**Technical Bulletin**

**TB5000-058**

5000 Bodymaker

## **Rear Air Bag Exhaust Plumbing**

Figure 1

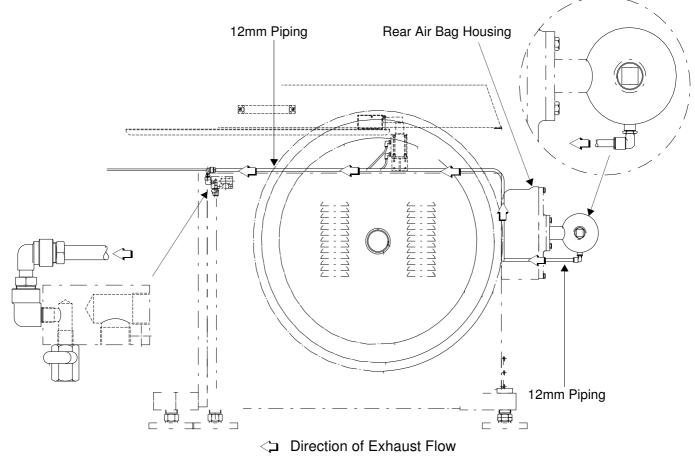
As a result of customer feedback and after in house trials CarnaudMetalbox Engineering have upgraded the Rear Air Bag Exhaust Plumbing Piping from 6mm to 12mm. This upgrade continues to use the existing exhaust valve fitted to all bodymakers as standard but bypasses the non return valves. As a result exhaust times are considerably reduced and production maximized.

This upgrade is applicable to both the Standard (See Figure 1) and Rear Air Bag Monitoring System (See Figure 2) designs fitted to CarnaudMetalbox Bodymakers and takes less than an hour to implement.
